Environmental Impact Report

222 KEARNY STREET

Final

State Clearinghouse No. 83030813

FIGURE 32: (Revised) Alternatives 4A and 4B - Guiding Downtown Development

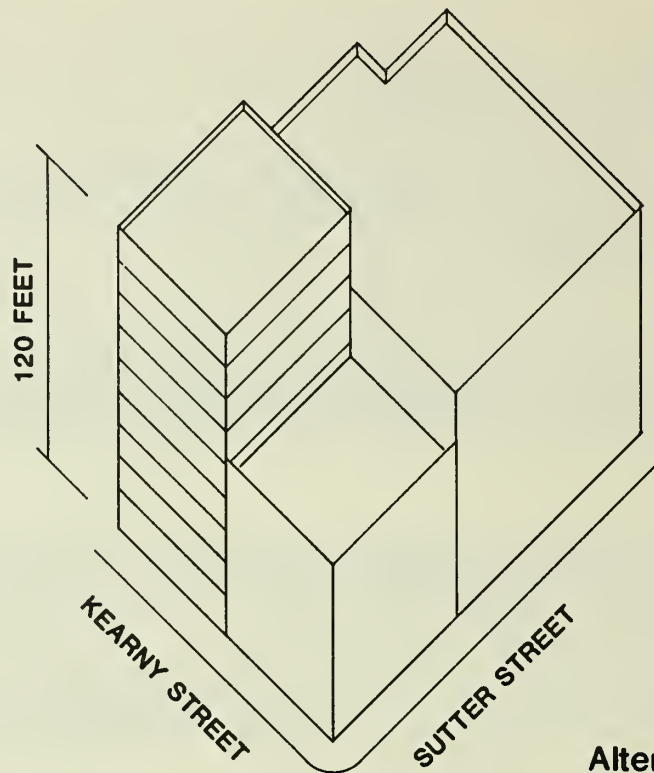
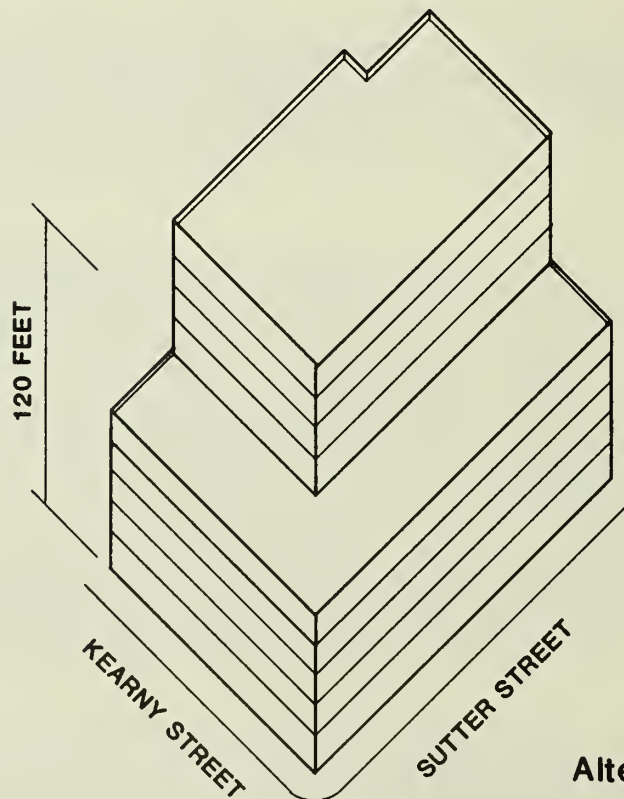
Existing buildings at the project site all exceed the 50-ft. height limit proposed in the AIA Kearny Street Corridor report. Alternative 2A, Preservation of All Site Buildings, would be consistent with recommendations of the AIA report.

Figure 32, p. 148 (p. 228 of this section) which shows the GDD alternative, has been revised to include a figure showing Alternative 4A, assuming a 120-ft. height limit for new construction at the site of 220 Kearny St. This would allow a more feasible floor configuration, because of reduced elevator and core space, compared to the taller alternative described on p. 140 (Alternative 2B). Alternative 4A is discussed on pp. 143-146, and, as noted on p. 144, paragraph one, would be similar to Alternative 2B.

"(See Alternative 4A, Figure 32, p. 148, for an alternative that would approximate this one.)" has been added at the end of the second sentence, paragraph two, p. 140 of the EIR. "(See Figure 32, p. 148)" has been added at the end of the second sentence, paragraph one, p. 144 of the EIR.
